CPED STAFF REPORT

CPC Agenda Item #6
August 25, 2014
BZZ-6674

Property Location: 2316-2320 Colfax Avenue South
Project Name: 2316-2320 Colfax Avenue
Prepared By: Aaron Hanauer, Senior City Planner, (612) 673-2494
Applicant: Michael Lander, Lander Group
Project Contact: Pete Keely, Collage Architects
Request: To allow for the construction of a four-story, 42-unit apartment building
Required Applications:

1 AS100 SITE PLAN
SCALE: 3/32" = 1'-0"

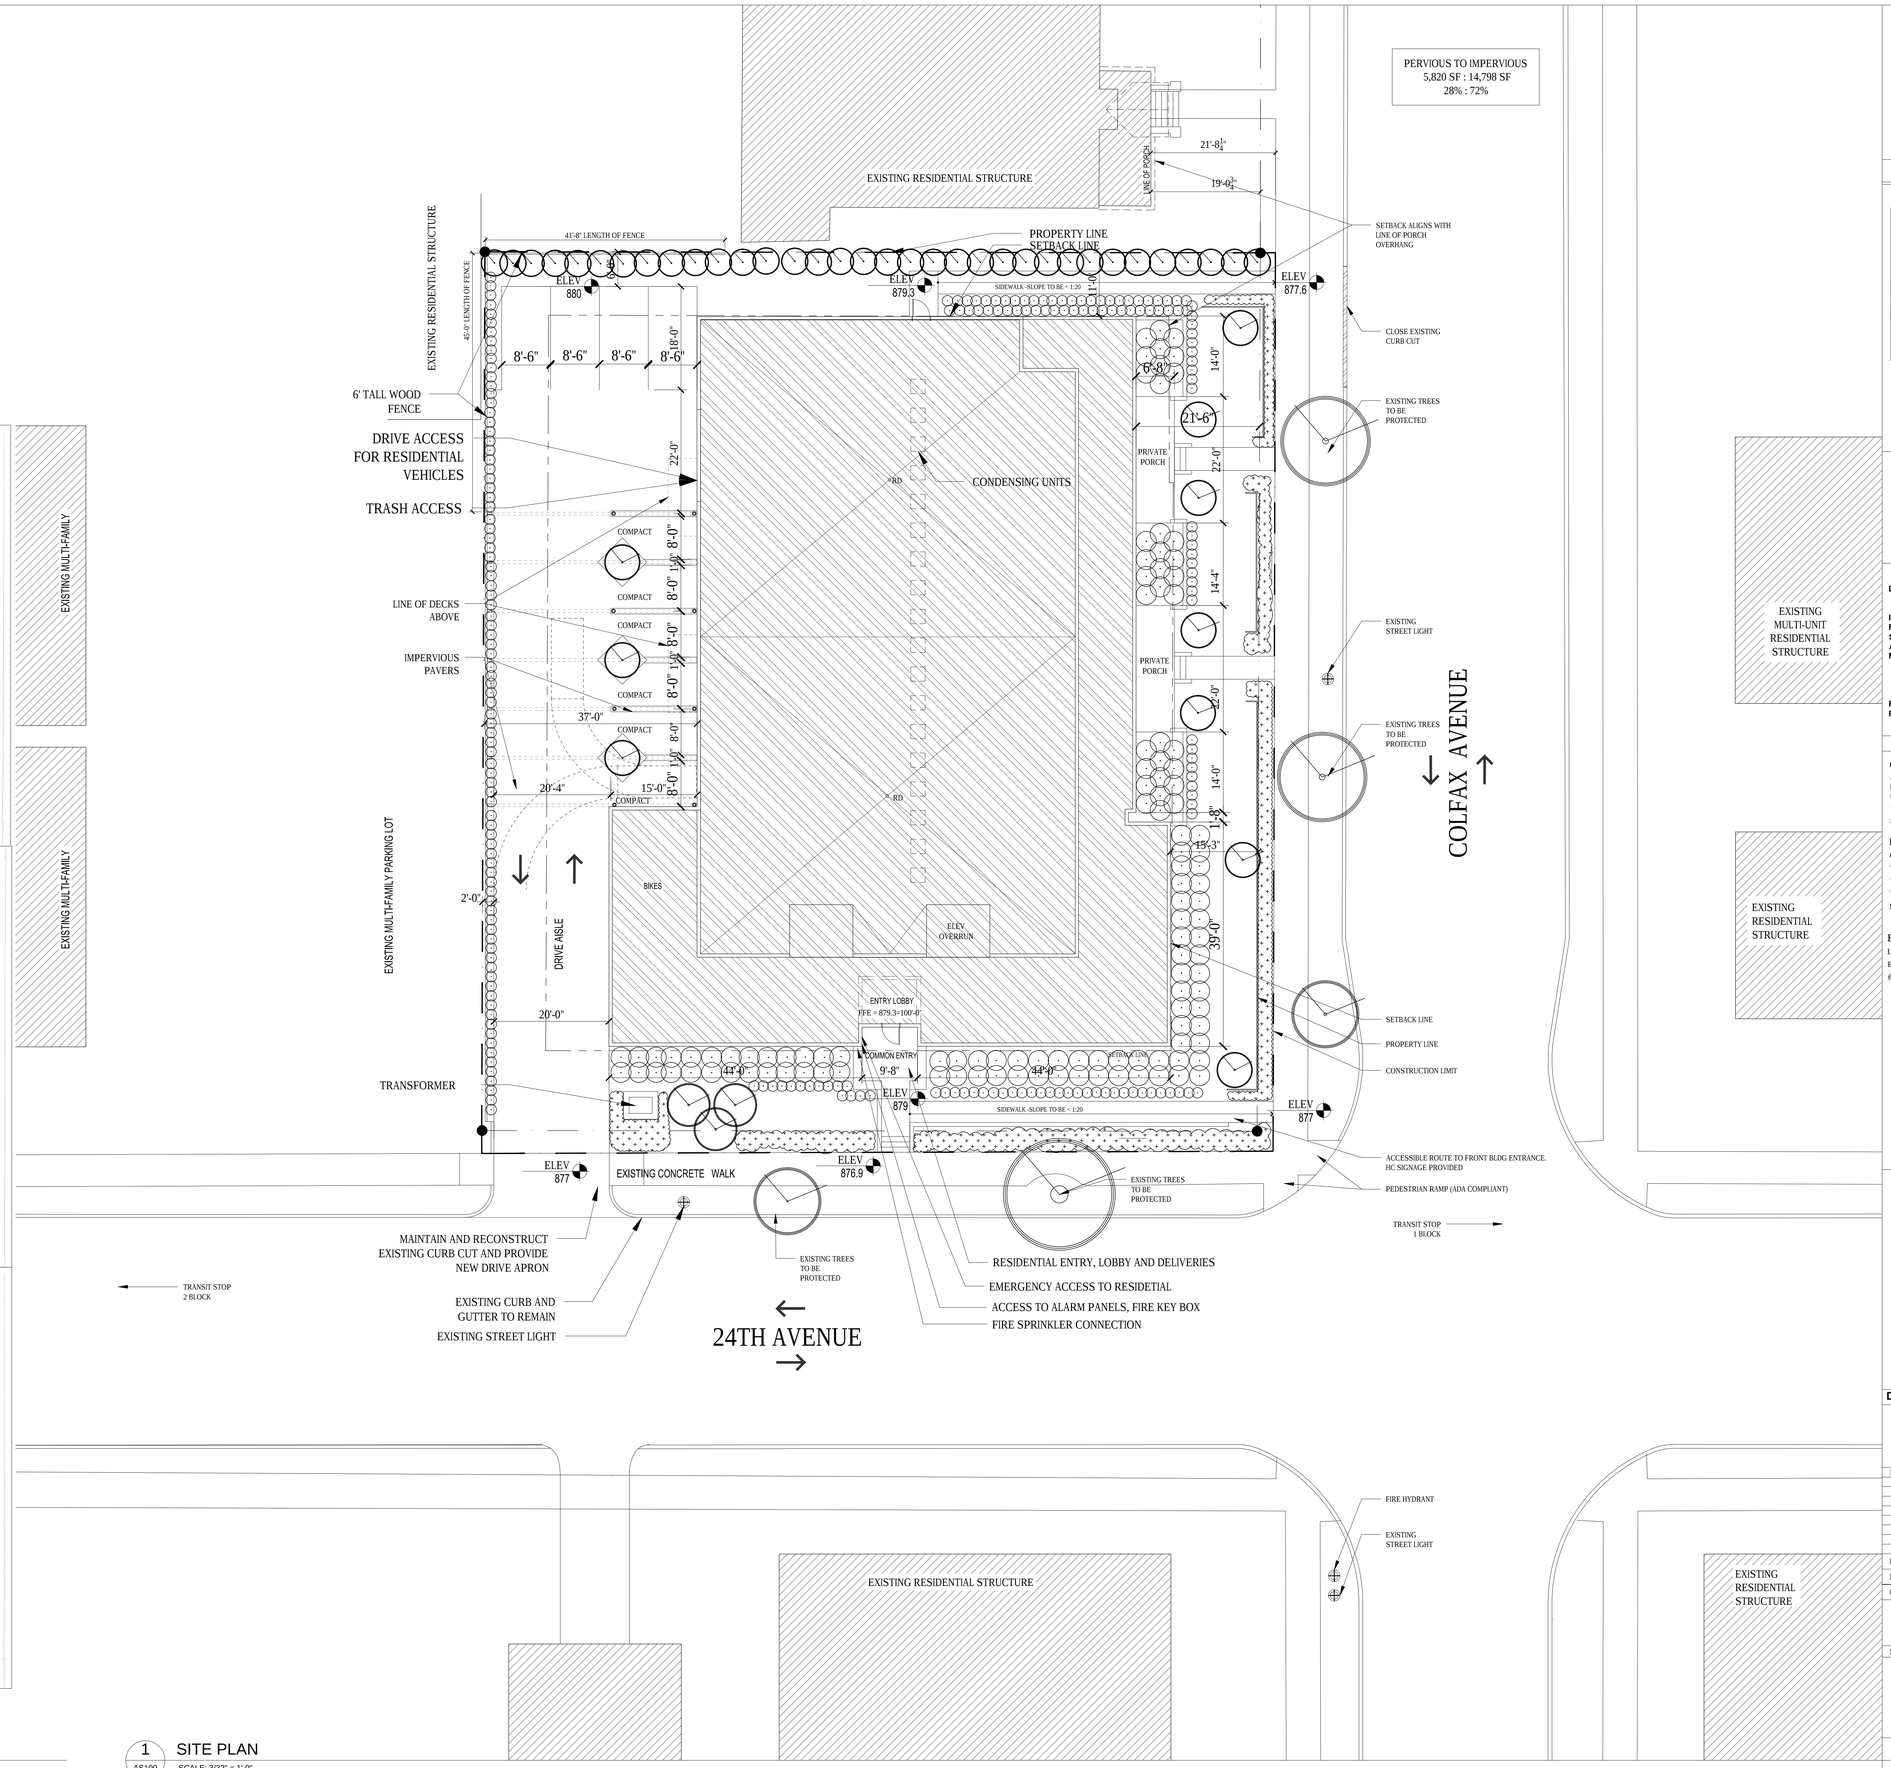
The applicant is proposing to reduce the minimum rear yard requirement adjacent to the west property line from 5 feet to 0 feet to allow a pergola over the parking area. The applicant is proposing the pergola to provide screening for the drive aisle and parking area. Practical difficulties exist in complying with the ordinance because of circumstances unique to the property. The unique circumstances were not created by persons presently having an interest in the property and are not based on economic consideration alone. Typical residential lots in Minneapolis have alleys; the subject property does not. If the subject property did have an alley, the applicant would have an additional five feet to locate the pergola outside of the required setback. In addition, if the project site had an alley it would not have to provide a 20-foot wide drive aisle along the western/rear property line to access the site thus providing more real estate to accommodate the pergola outside of the rear yard setback.

The applicant is proposing to provide 32 off-street parking spaces (18 standard and 14 compact). Because the proposed number of compact spaces exceeds the maximum number allowed to count toward meeting the minimum parking requirement, the applicant is not able to count five of the proposed off-street parking spaces towards their minimum. Therefore, the proposed variance is to reduce the minimum parking requirement by 11 spaces; from 38 spaces to 27 spaces.

The Department of Community Planning and Economic Development has analyzed the application for a variance_to reduce the minimum two-way drive aisle width from 22 feet to 20 feet based on the following findings:

- Relocate accessible parking spaces and access isle locations to provide closest route to accessible entrance per MNSAC 1341.1106.6
- At least one parking space shall be Van accessible, and shall provide vehicular entrance, exit, route, access isle and parking space with 98 inches vertical clearance.

- If a 2nd entrance for tenants and public is provide, it is required to be accessible per 1341.1105.1 (i.e. North exit door)
- Include in the building code analysis, a calculation of wall openings (actual vs. tabular) for the North building elevations per IBC table 704.8 due to distance to property line.

1. The final plans shall include the additional compact parking spaces as proposed.
2. A space shall be dedicated for the shared vehicle on the final site plan/floor plans.
3. The proposed project shall provide no less than the proposed 48 bike parking spaces that meet the zoning code's requirements for long term bike parking. The bike transit center shall be maintained in the final construction plans that will allow for a space for residents to complete bike repairs.

The Department of Community Planning and Economic Development recommends that the City Planning Commission adopt the above findings and **approve** the application for a variance to reduce the minimum two-way drive aisle width from 22 feet to 20 feet for the proposed project located at 2316-2320 Colfax Avenue South.

1 L100 LANDSCAPE PLAN
SCALE: 1/8" = 1'-0"

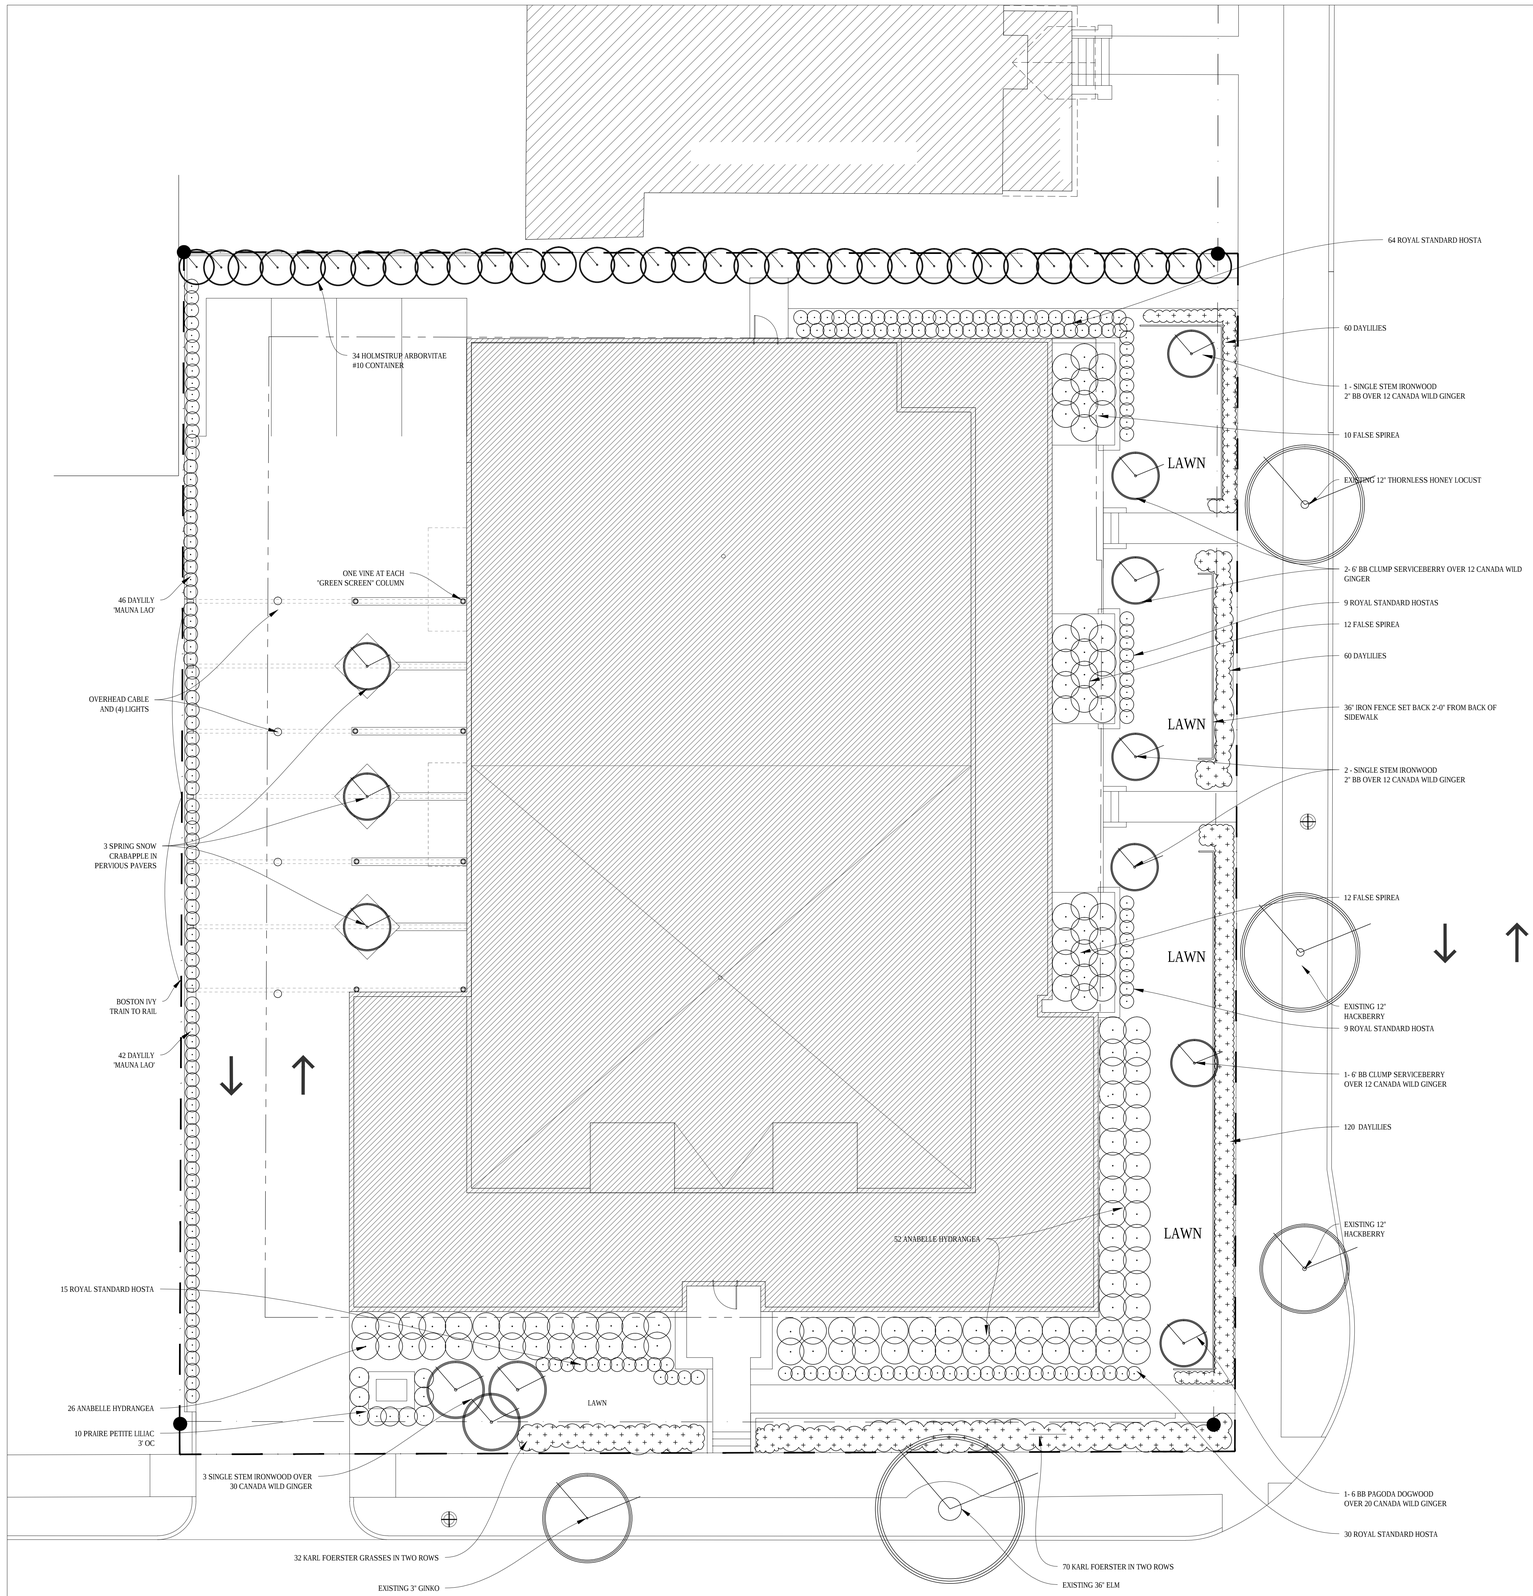
- The applicant's landscape plan will exceed the landscaping requirements outlined in Section 530.160 (a) of the zoning code (see Table 3 below).
- Per 530.170 (b) (2), the applicant is required to have six-foot high screening for the parking area that abuts a residence to the north and west outside of the front yard. The applicant is proposing a six-foot tall privacy fence along a portion of both property lines. Along the northern property line, the proposed fence would fully extend the length of the parking area. Along the western property line, the privacy fence would extend for 45 of the 95 linear feet of parking and drive aisle area. Alternative compliance is required.

- Information is not provided on the landscape plan regarding the installation and maintenance of all landscape materials. Installation and maintenance will need to comply with section 530.210 of the zoning code.

proposing to have a six-foot wide landscaped yard along the northern property line of the parking area and a two-foot wide landscaped yard along the western property line of the parking area. Respectively, this is one foot less and five feet less than is required. The landscaped yard requirement is in place to reduce the impact of off-street parking on neighboring properties. The applicant proposing smaller landscaped yards at these location in order to provide four standard parking stalls along the northern property line and to accommodate a functioning, 20-foot wide, two-way drive aisle and six compact parking spaces along the western property line. To reduce the impact of the narrower landscaped yards, the applicant is proposing to install a six-foot high privacy fence as well as plant arborvitae on the northern property line and a six foot privacy fence and a pergola along the western property line. CPED is recommending that the Planning Commission grant alternative in reducing the width of the landscaped yards as proposed along the northern and western property lines because the proposed alternatives meets the intent of this chapter and the site plan includes additional screening than what is required.

- **Tree island width of seven feet.** The applicant is proposing the tree islands be 4.25 feet by 4.25 feet of pervious pavers for the three crabapple trees in the surface parking area. The site plan review chapter requires that the tree islands be seven feet in width in any direction. This requirement is in place to provide sufficient room for the trees to gain water and have their root system grow. The applicant is proposing the reduced width because of the limited space between the ornamental crabapple trees and the parking stalls. CPED is recommending the the Planning Commission grant alternative compliance in reducing the tree island width at this location because it will allow a smaller decidious tree to grow near the surface parking spaces and help meet the city goal of screening off-street parking and reducing the heat island effect. In addition, the applicant states that the project landscape architect is confident that the crabapple trees can successfully grow with the proposed tree island width.

1. All other areas of the site not governed by 530.160 and 530.170 and not occupied by buildings, parking and loading facilities or driveways will be covered with turf grass, perennial flowering plants, vines, wood mulch, shrubs or trees. The proposed landscaping outside of the project's property lines will require an encroachment permit.

4. The Department of Community Planning and Economic Development staff review and approval of the final building elevations, floor, site, lighting and landscape plans. A lighting plan shall be submitted that is in compliance with Section 535.590 and 541.570 of the zoning code.

MINNEAPOLIS DEPARTMENT OF PUBLIC WORKS | DRAWN: JFC | DATE: 9/10/07 | APPROVED: GAS | DATE: 5/19/08 | TYPICAL DRIVEWAY | STANDARD PLATE NO. ROAD-2002

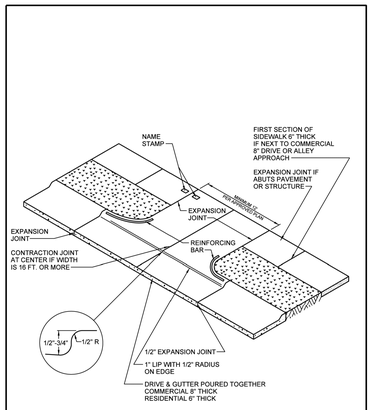
- The proposed driveway apron at the parking lot entrance along W. 24th St. shall be shown graphically correct on all plan sheets; refer to the City Standard details provided on Sheet C8-1 of the submitted site plan.
